CITY OF MELBOURNE

WEST GATE TUNNEL INQUIRY AND ADVISORY COMMITTEE

CITY OF MELBOURNE SUBMISSION WEST GATE TUNNEL PROJECT

Figure 2: Footscray Road, Dynon Road and Wurundjeri Way extension **Source:** Figure 5-12 of the EES.

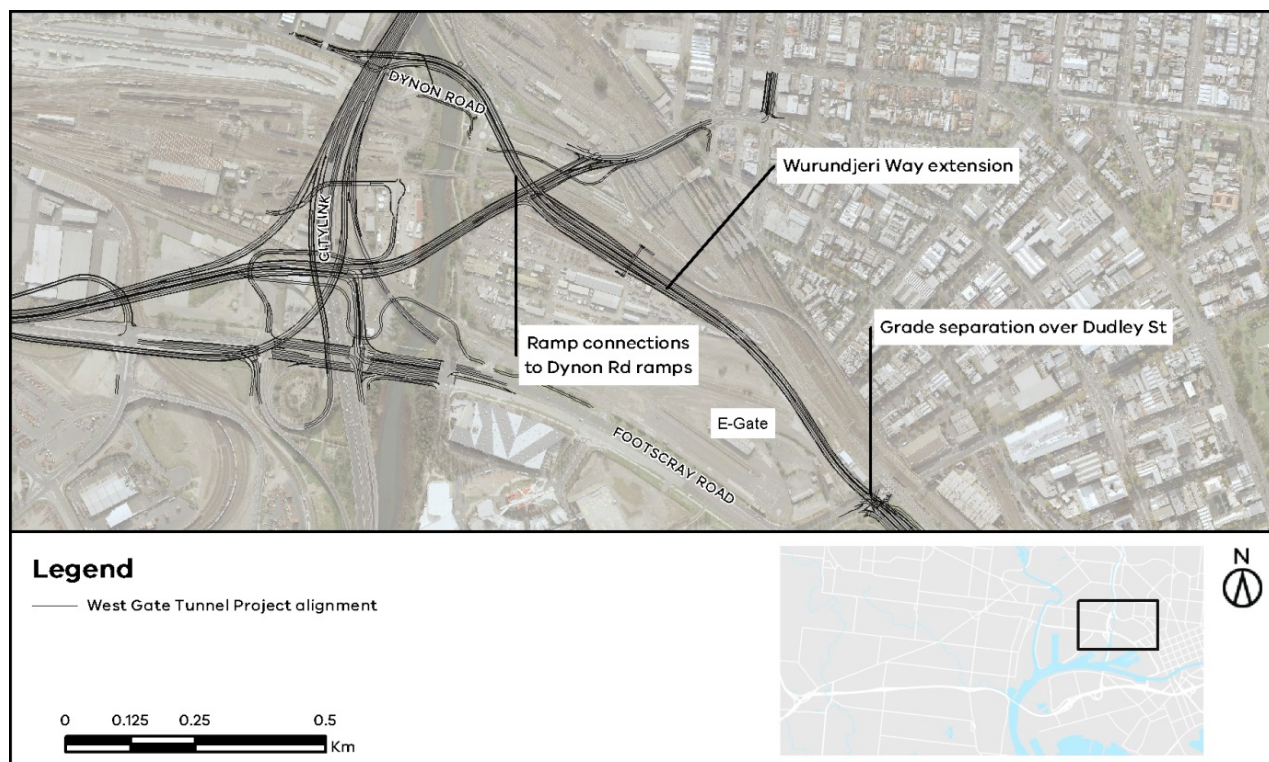
The City of Melbourne opposes the Project's connection to Dynon Road. The Dynon Road connection has limited strategic rationale, particularly in relation to the Project's objectives. It will introduce significant amounts of traffic onto local streets in North Melbourne and beyond, which will undermine the operation of key economic precincts such as the biomedical precinct and the innovation district as well as existing public transport. This section of the Project is in conflict with City of Melbourne policy and undermines decades of work to reduce through traffic in this precinct. The City of Melbourne does not consider that the impacts of this connection can be managed or mitigated; and therefore submits that the connection should not be constructed as part of the Project.

Figure 4: Cross section of the Footscray Road Elevated Structure **Source:** EES Map Book

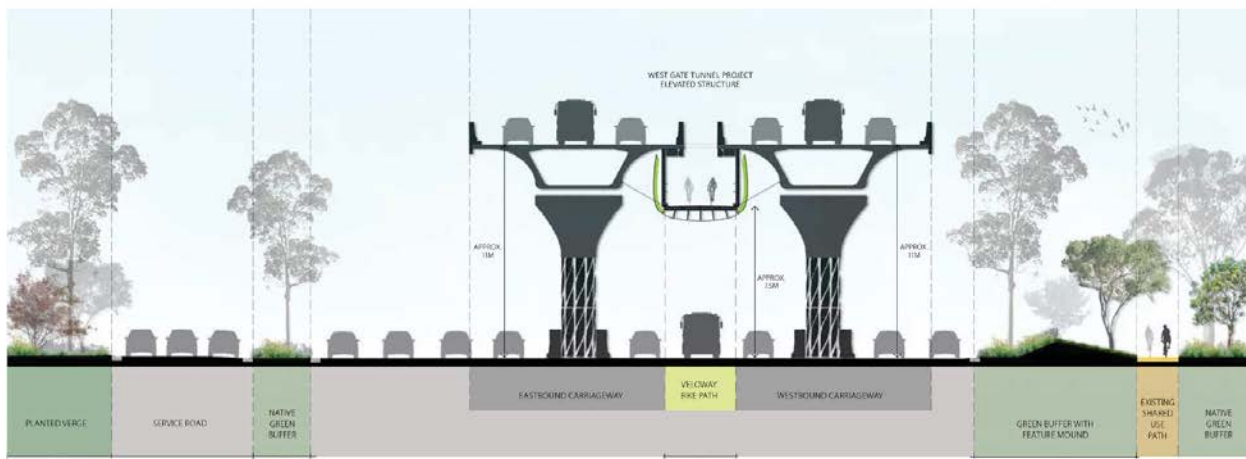
The City of Melbourne is opposed to the elevated structure along Footscray Road.

form	elevated Footscray Road structure, have not been adequately assessed.
Landscape and Visual Impact	<p>7. Landscape and visual impact of the elevated roadway structure on Footscray Road and surrounds has not been adequately assessed.</p> <p>8. The impact on the realisation of Footscray Road as a boulevard, as identified in the Melbourne Planning Scheme, has not been adequately assessed.</p> <p>9. Mitigation strategies proposed for acknowledged landscape and visual impacts as a result of the Footscray Road elevated structure are not adequate.</p>
Urban Forest	<p>10. The impacts on the urban forest, including its amenity, landscape and ecology, as a result of the loss of approximately 537 trees along the Footscray Road corridor have not been adequately assessed or mitigated.</p> <p>11. The impact of the Project on growing conditions along Footscray Road has not been adequately assessed.</p>

Failing this, the City of Melbourne considers that the Footscray Road section should be redesigned with an associated rationalisation of the existing road conditions along Footscray Road. This would have a reduced negative impact on urban renewal and built form outcomes along this corridor as well as future permeability. It would also provide enhanced opportunities for open space and landscaping and the provision of public and active transport.

If the Project is to proceed as an elevated structure, the elevated structure should be redesigned to mitigate the impacts of the design. This includes improving the ability for ground level amenity and functionality – the current height of the structure doesn't provide for this to occur, the rationalisation of traffic lanes at surface and the relocation and redesign of the veloway (see further discussion at section 4.6).
